## Notice of REVISED Administrative Decision

**RE:** **Permit Number:** 18-00731  
**Project Name:** Silver View Apartments ACUP Hearing Examiner Remand and Appeal  
**Type of Application:** Administrative Conditional Use Permit (ACUP)

## Administrative Staff Report

**Project Name:** Silver View Apartments Hearing Examiner Remand and Appeal  
**Type of Application:** Type-II Administrative Conditional Use Permit  
**Permit Number:** 18-00871 (HE Administrative Appeal 20-04126)

**Diagram of Pedestrian Improvement Frontage improvements**

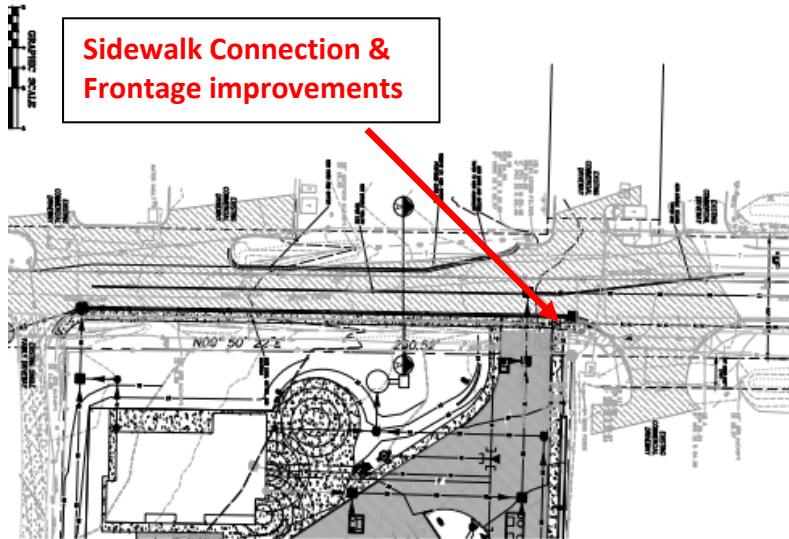
The project was reviewed for potential pedestrian and vehicular traffic impacts, which included analysis of adjacent intersections to monitor the vehicular level-of-service. There are property frontage improvements required along Mickelberry Road NW consisting of an 11-foot travel lane and 5-foot sidewalks. (Please see Condition 35).

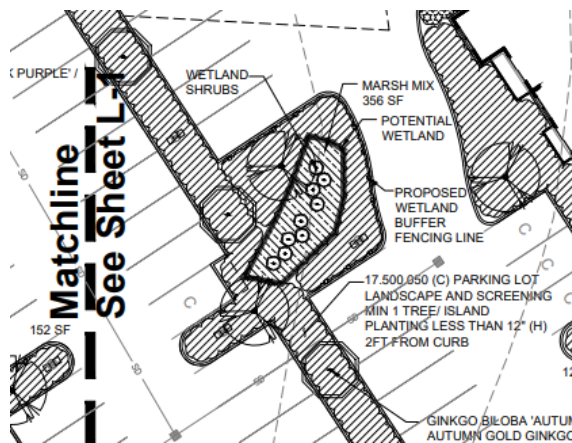
The project proposed to collect stormwater runoff from a majority of the developed project site area into a proposed storm conveyance system where it will be treated for water quality prior to discharging into a new storm system to be constructed within Mickelberry Road NW. The new storm system will convey stormwater to the existing storm system located in NW Bucklin Hill Road. Connection will be to an existing Type 2 Manhole located along the flow line of south side of NW Bucklin Hill Road. This stormwater connection from the site will be conveyed to the existing 48-inch diameter storm water from the site will be conveyed to the existing 48-inch diameter storm pipe, stormwater from the site will flow approximately 700 feet west where the storm pipe empties into Dyes Inlet at the same location where the stream of Clear Creek empties into Dyes Inlet. The connection of the storm system into Dyes inlet and the fact that the existing system has adequate capacity, direct discharge without detention is allowable for this site.

The remainder of the drainage on the project site will be collected, treated, and conveyed to a second new storm system which will also collect the offsite runoff. This stormwater will then be discharged to the natural discharge location at the southwest corner of the project site. The storm runoff released to the natural discharge point has been designed to be less than the runoff released from the site in the current condition and as such no additional detention will be required. Staff comments are based on review of the latest amended Preliminary Storm Drainage report, and engineering plans accepted for review on July 19, 2022. Development Engineering and third party reviewer

accepts the storm drainage design and issued preliminary conditions of approval dated December 12, 2022 (see Storm Drainage Plan Attachment - B).

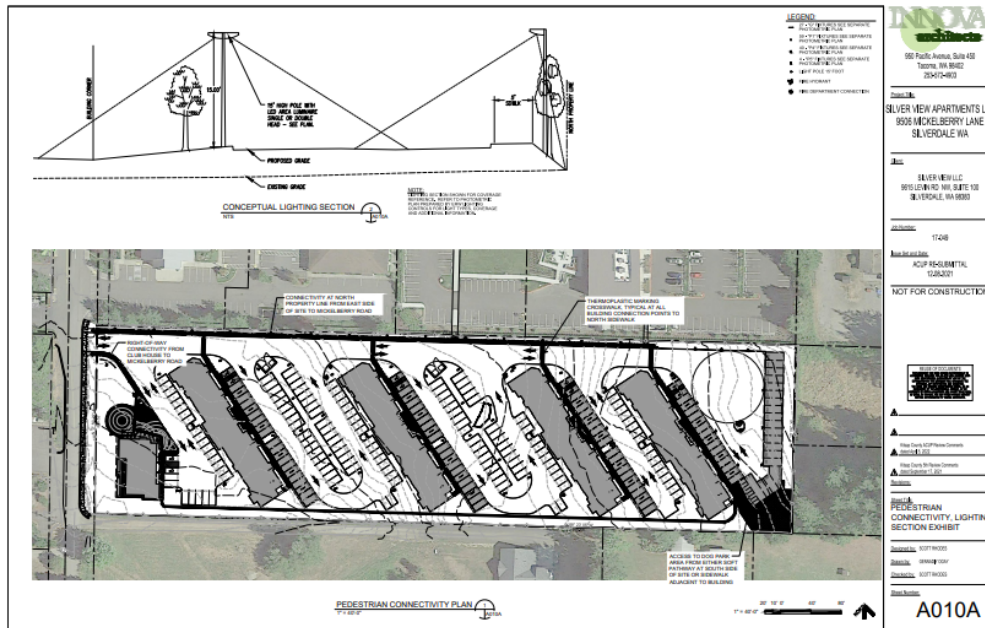
Hearing Examiner Comment (HE): While the code does authorize a parking reduction based on public transit reducing the parking demand, the ACUP and record are confusing on the mitigation being provided and the ACUP does not detail how transit will operate to reduce parking demand. Improving transit access may accomplish this objective. But the ACUP does not detail how, and the actual mitigation imposed requires clarification.

Applicant Response: The project provides 245 parking spaces, which is 25% or 75 less than KCC 17.490.030 otherwise requires for apartments (1.5 per unit plus .5 on street or set

**Staff Response:** The applicant demonstrates through mitigation that the parking standard exceeds demand which is allowed pursuant to WAC 468-63 and KCC 17.490.030. Project provides pedestrian access through the site to Mickelberry Road. Project includes frontage improvement along Mickelberry Road (curb gutter and sidewalk). Residents with bus passes will be able to use pedestrian access to the bus stop located on Bucklin Hill Road.

### Colored Site Plan – Project layout

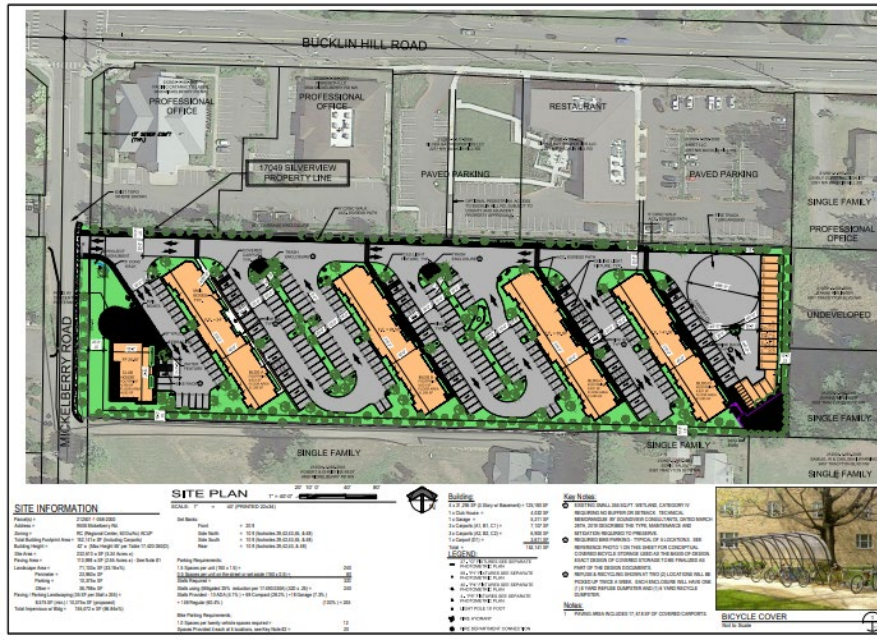
HE Comment: Per the Hearing Examiner Finding #16, the project site plan and narrative do not demonstrate compliance with the Silverdale Design Guidelines Section 9.4.3A., requiring parking to be oriented to the side or rear yard. Mr. Adams detailed how the project does not comport with the Design Standards. The Design Standards (and Comprehensive Plan) require the project to be respectful of single-family development (see Comprehensive Plan LU Goal 1 and Policy 1) (*See design standards -Revised Architectural Narrative Response to County Comments, July 15, 2022*).

**Staff Response:** Staff concurs the project can operate as a transitional use between the more intensive commercial uses along Bucklin Hill Road to the north within the RC zone and provides a separation between the UR zone and associated single-family homes. The site plan shows the more intensive activities such as off-street parking adjacent to the RC zone. The building profiles show the apartment building stepped down with a screening buffer along the south and east property lines which reduces impacts to the Urban Restricted zone.

Attachment B - Storm Drainage Conveyance Map (C3.0 Civil PLANS)

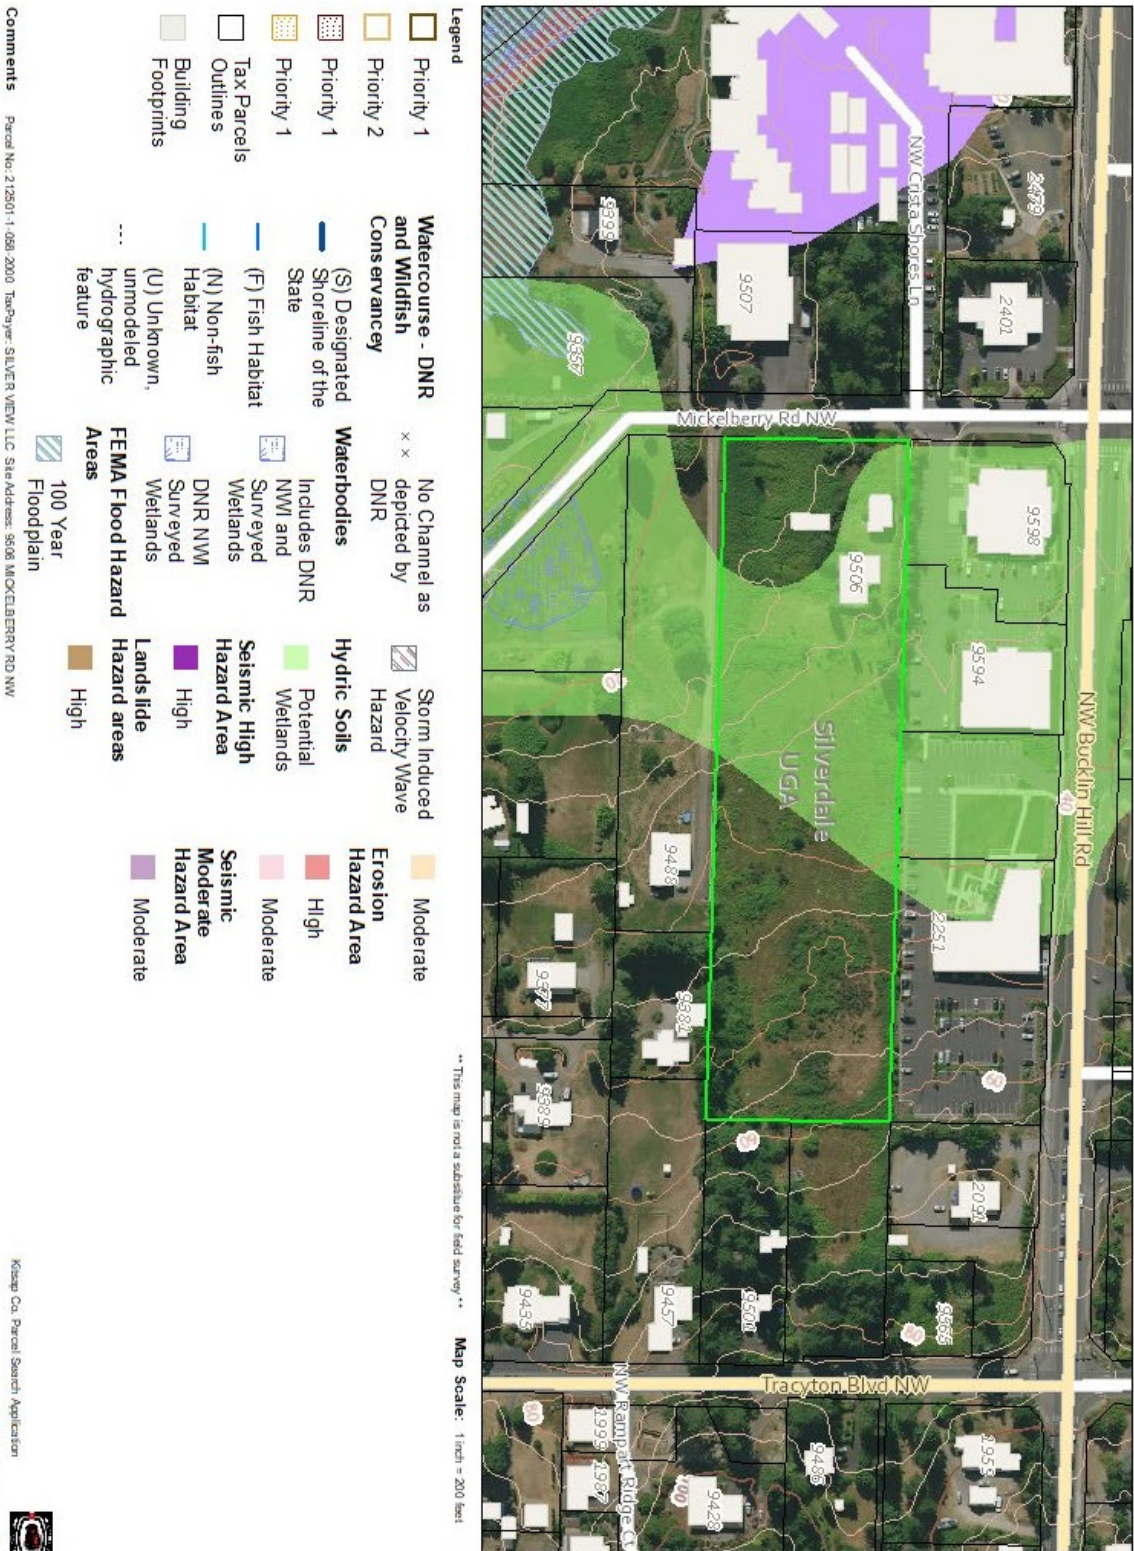
**HE Comment:** Infrastructure “viability” is a pre-requisite to ACUP approval and must be addressed in the environmental review. The County Stormwater Manual states, “[p]erforming a comprehensive inventory analysis is an essential first step to site assessment and planning and must precede site design.” This was not disputed. Further detail will be provided during Site Development Activity Permit Review per KCC Title 12 and building permit review, but system viability must be present at the land use review (ACUP and SEPA) stage. The above discussion addressed discharge to the north. There are also issues with the southern discharge point. This runoff will discharge on neighboring properties and run down to the lagoon and Dyes Inlet. Untreated runoff has the potential to significantly affect these resources. Dr. Cooke detailed stormwater

This site is allowed to have as much as 85% impervious areas. The proposed project has less than 67% impervious area, providing more than twice the required pervious area. All pavement areas of this project are designed with water quality treatment meeting the current county stormwater quality treatment regulations. Those treatment structures are shown on the civil plans and stormwater report dated July 12, 2022, which were submitted to the county on July 19, 2022, and form the basis of this application and its associated SEPA issuance. Almost all the surface water from the site will not flow to the downstream region of Mickelberry Road, but rather the majority of the stormwater is directed to the public stormwater pipe conveyance system in Bucklin Hill Road which was designed by the county for this site drainage. The only water to flow to the downhill ditch and pipe system on Mickelberry Road are the flows which were flowing there in the pre-developed condition. Those flows came from the nearby subsurface flows coming from uphill of this site. That water is collected in new underground perforated pipe drains placed at the top of the hill and eastern edge of the site and along the foundation walls of each building, collecting the flows that naturally flowed to the ditches in Mickelberry Road. Those subsurface flows are collected in underground pipes and routed under the pet area in what will be solid pipes and then routed in solid pipes under the east and south edges of the site down to the Mickelberry ditch. This water is clean water from subsurface drainage not related to surface flows on the site. To match the surface flows of what fell onto the surface of the site in the pre-developed condition, a small area of new impervious area near the club house is treated with current required water quality treatment systems and then discharged to the ditch so that the post-developed flow matches the predeveloped flow. This has been carefully engineered so there is no pollution going to the downstream ditch and pipe system and there also is no change in water volume flowing to that ditch and pipe system. The entire storm system has been designed with pipe sizes and pipe elevations shown by calculation in the storm report and on the civil plans as properly sized to carry the required flows.

The storm system connecting offsite to the Bucklin Hill Road storm conveyance system flows by gravity and that system has been designed and shown on plans and calculations showing pipe size and pipe elevation to be of the required size and slope required to

*Staff Response: Staff concurs that the applicant has provided additional analysis which exceeds the 60% design margin supporting conveyance to the north to Bucklin Hill Road, metered storm drainage to the wetland and conveyance of existing flows off-site to the southwest corner of the project site (see Attachment - B).*
